# UNITED STATES PATENT AND TRADEMARK OFFICE

| APPLICATION NO. | FILING DATE | FIRST NAMED INVENTOR | ATTORNEY DOCKET NO. | CONFIRMATION NO. |
|-----------------|-------------|----------------------|---------------------|------------------|
| 10/637,929      | 08/07/2003  | Chien-Kuo Chang      | 13880 B             | 1946             |

# Office Action Summary

Gigante Fig. 1

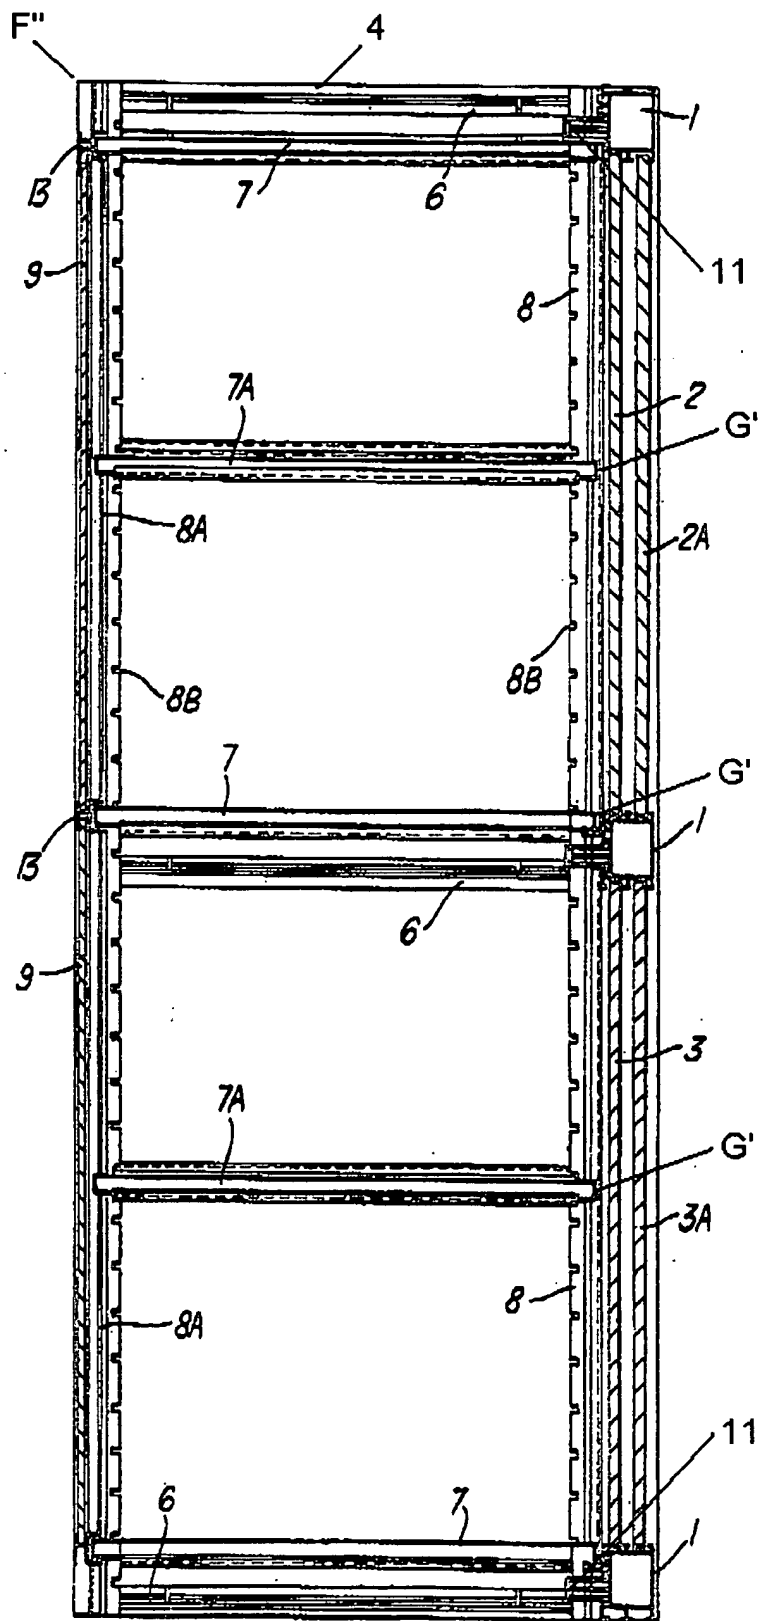
11. Regarding claim 1: In Fig. 1, Gigante shows a shelving unit comprising: a plurality of supporting frame bars arranged in parallel (F', F'', F'''). In Fig. 2, Gigante shows a cross section of a shelving unit including supporting frame bars (F'') each comprising an elongated vertical frame portion (8A), an elongated top horizontal frame portion (6) perpendicularly extended from the top end of the elongated vertical frame portion (8A), and an elongated bottom horizontal frame portion (6) perpendicularly extended from the bottom end of the elongated vertical frame portion (8A) and disposed in parallel to the elongated top horizontal frame portion (6), a back panel (9) fastened to the elongated vertical frame portions (8A) of the supporting frame bars (F'') and supported between the elongated top horizontal frame portions (6) and elongated bottom horizontal frame portions (6) of the supporting frame bars (F''), a bottom panel (7) fixedly fastened to the elongated bottom horizontal frame portions (6) of the supporting frame bars (F''), a front open frame (1) fixedly fastened to the free ends of the elongated top horizontal frame portions (6) and elongated bottom horizontal frame portions (6) of the supporting frame bars (F'') and disposed in parallel to the back panel (9),

12. Regarding claim 2: In Fig. 1, Gigante shows a shelving unit, wherein the supporting frame bars include a left supporting frame bar (F'), a right supporting frame bar (F'''), and a middle supporting frame bar (F'') spaced between the left supporting frame bar (F') and the right supporting frame bar (F''').

Gigante  
Fig. 2

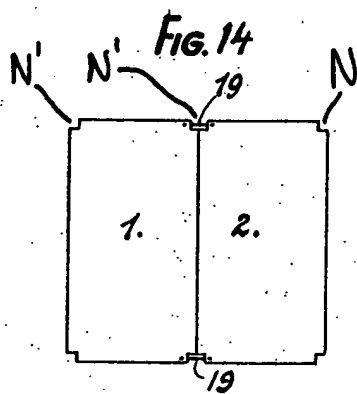
13. Regarding claim 6: In Fig. 2, Gigante shows a shelving unit, wherein the supporting frame bars (F'') each have at least one horizontal mounting lug (11) respectively provided at the free ends of the respective elongated top horizontal frame portions (6) and elongated bottom horizontal frame portions (6).

14. Regarding claim 7: In Fig. 2, Gigante shows a shelving unit, wherein the front open frame (1) is fixedly fastened to the horizontal mounting lugs (11) of the supporting frame bars (F'').

15. Regarding claim 9: In Fig. 2, Gigante shows partition board holders (13) comprising U-shaped clamps (13) fixedly fastened the back panel (9) by fastening elements (13).

FR-1,143,195-A

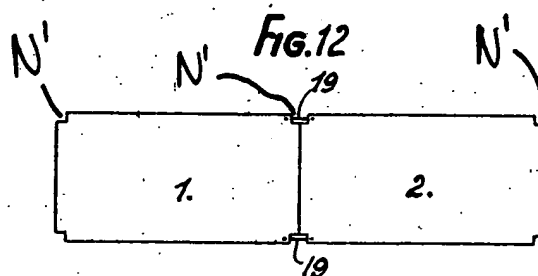
1,143,195-A). In Figs. 1 and 2, Gigante shows a shelving unit with all the aspects described in claim 1 and 2. In Fig. 2, Gigante shows a cross section of a shelving unit including the supporting frame bars (F'') each comprising an elongated vertical frame portion (8A), an elongated top horizontal frame portion (6) perpendicularly extended from a top end of the elongated vertical frame portion (8A), and an elongated bottom horizontal frame portion (6) perpendicularly extended from bottom end of the elongated vertical frame portion (F'') and disposed in parallel to the elongated top horizontal frame portion (6), but lacks a back panel with a plurality of top notches respectively disposed in a top side thereof and adapted to receive the elongated top horizontal frame portions of said left, right and middle supporting frame bars respectively. In Fig. 12, the French document teaches a panel with a plurality of top notches (N') respectively disposed in a top side thereof and adapted to receive frame members (19). It would have been obvious to one skilled in the art at the time of invention to utilize the back panel with a plurality of top notches of the French document to receive the elongated top horizontal frame portions of the left, right and middle supporting frame bars of Gigante to allow the back panel to extend past the elongated top horizontal frame bars portions.
